Minor Changes Key

Project
60 Whitfield Street

Title
**Proposed Elevation
North West Facade**

Drawing No	Revisions
60WS-A-SBA-DR-XX-4010-C6

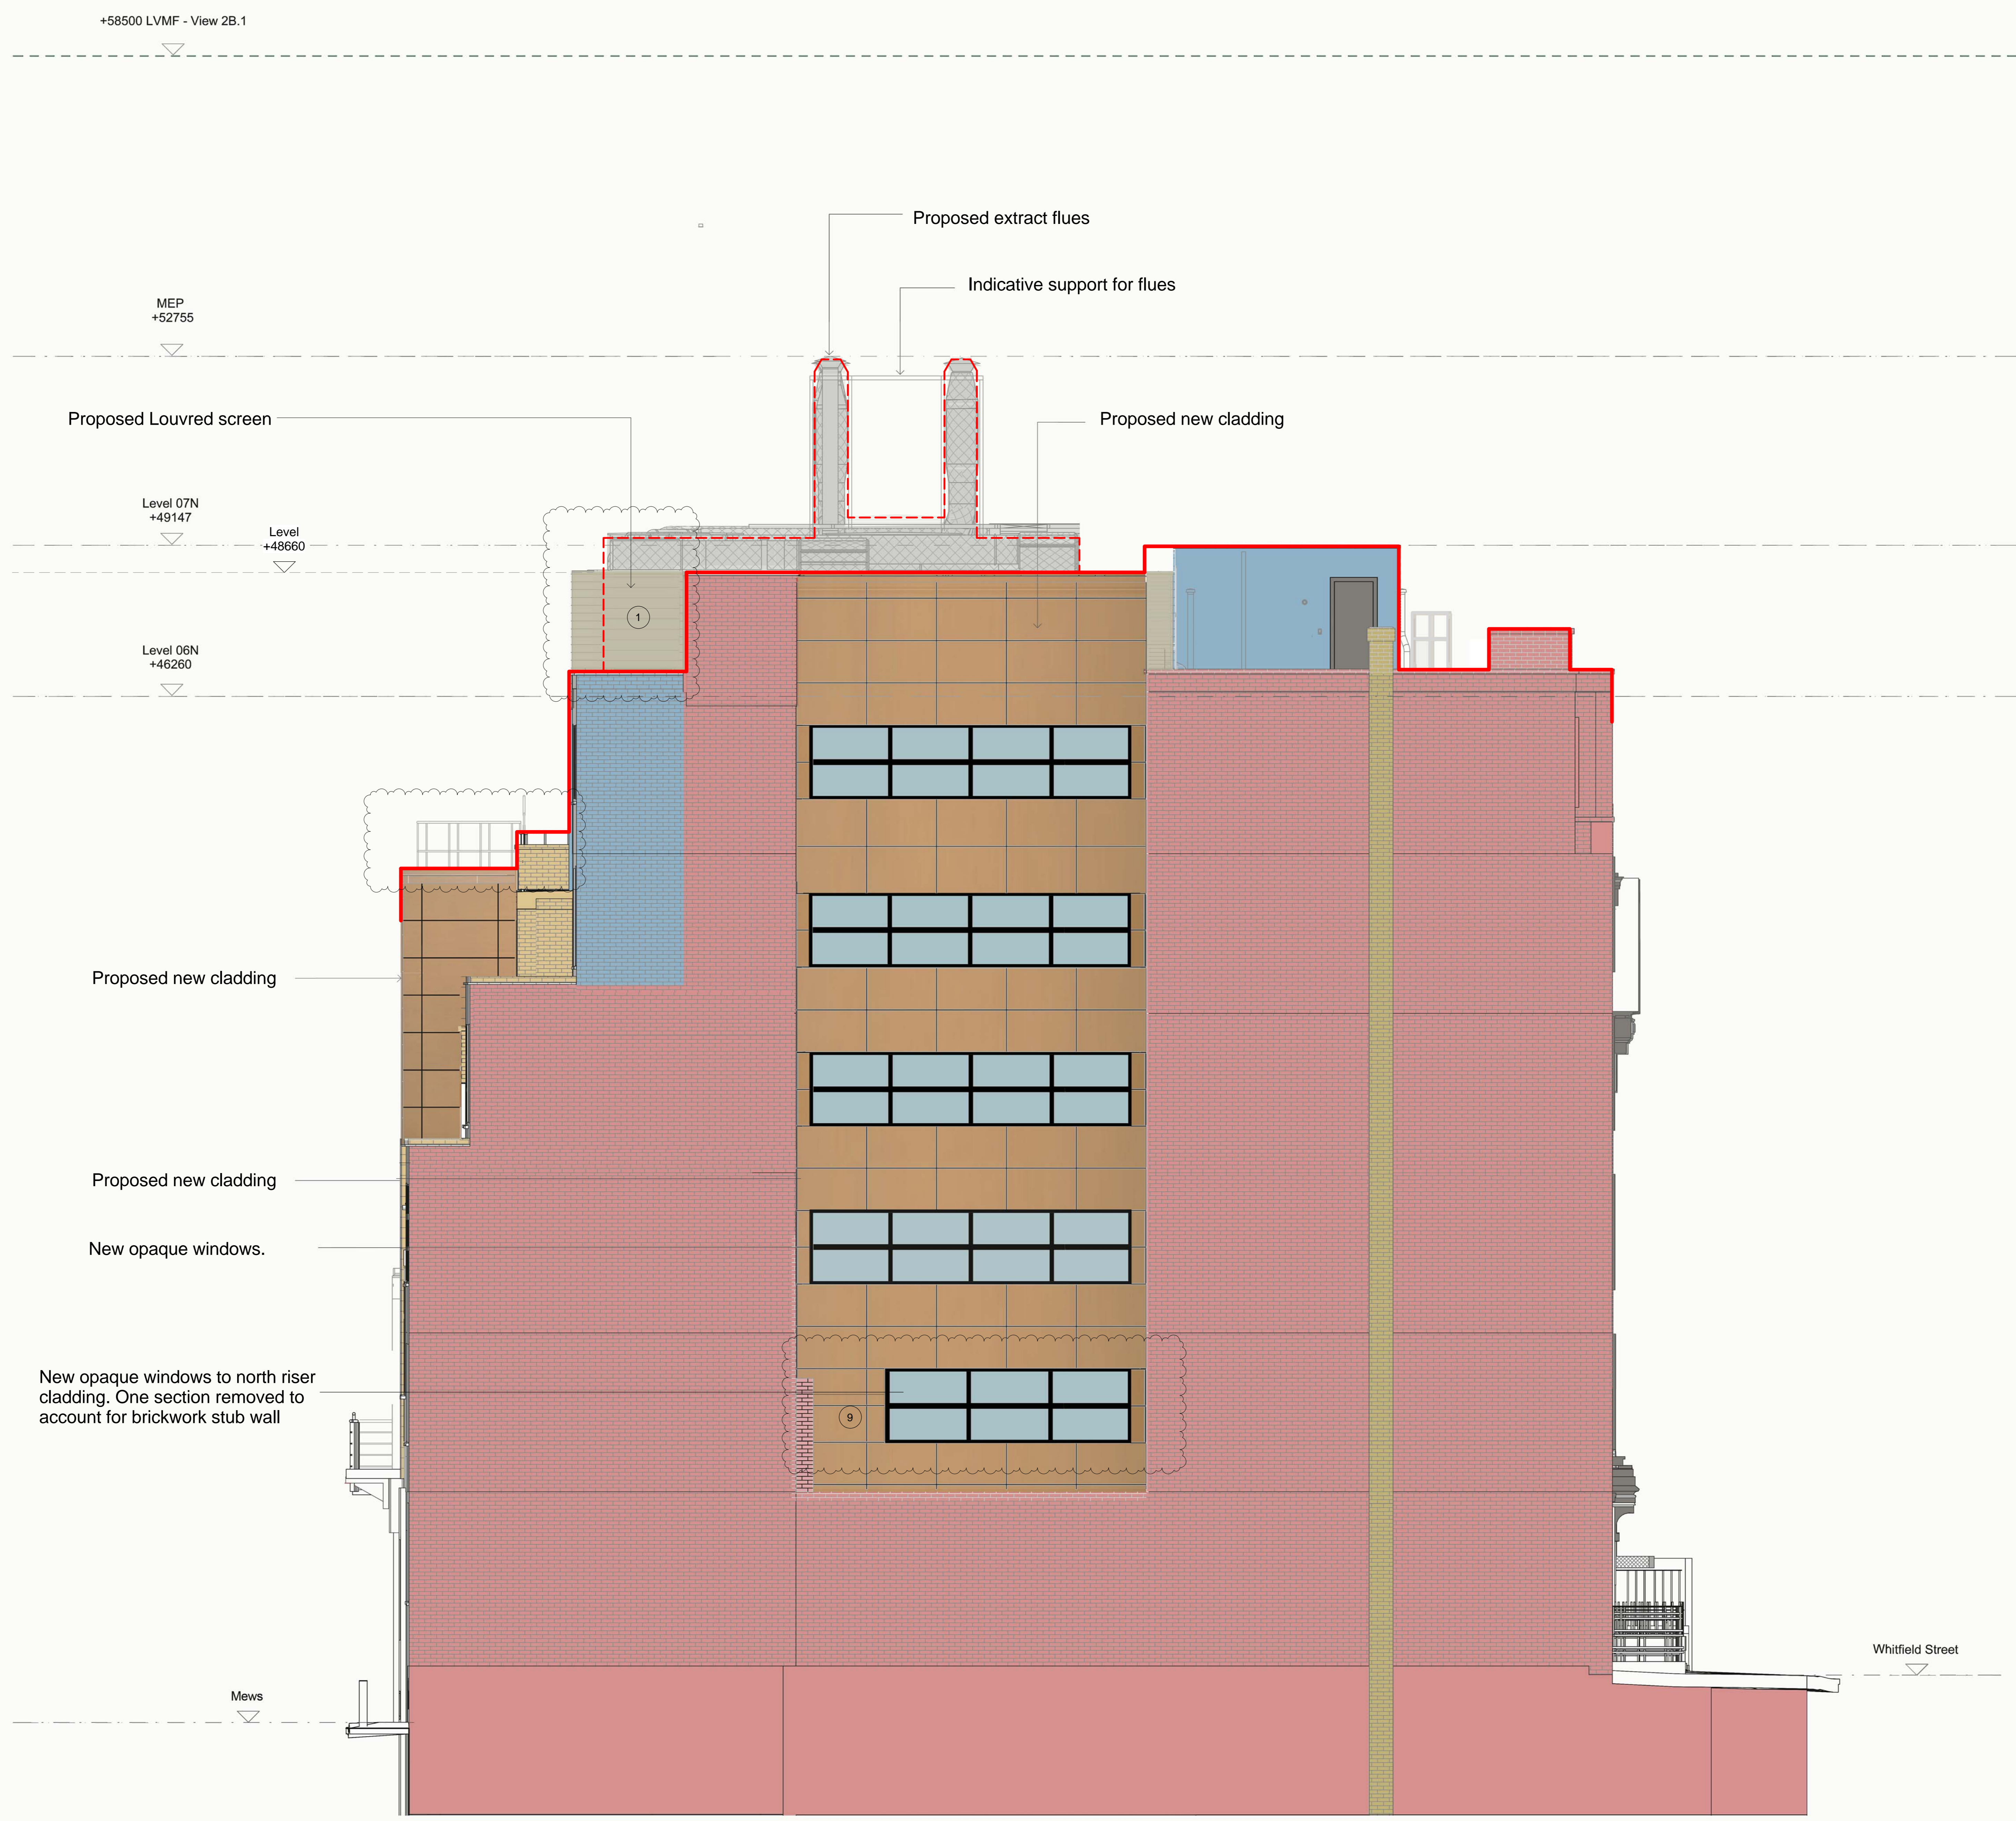
- 1 Louvre added to enclose MEP
- 2 Existing enclosure of Goldbeaters atrium is retained except two lateral walls
- 3 Scope of demolition of existing plant room on Walport building increased
- 4 Minor repositioning of approved flues
- 5 Maintenance cat ladder added to link Goldbeaters terrace with Walport terrace
- 6 Amended stair-landing levels
- 7 Parapet of dumbwells enclosure raised by 235mm
- 8 Reduced louvre height to match Howland Mews elevation
- 9 One section of window removed
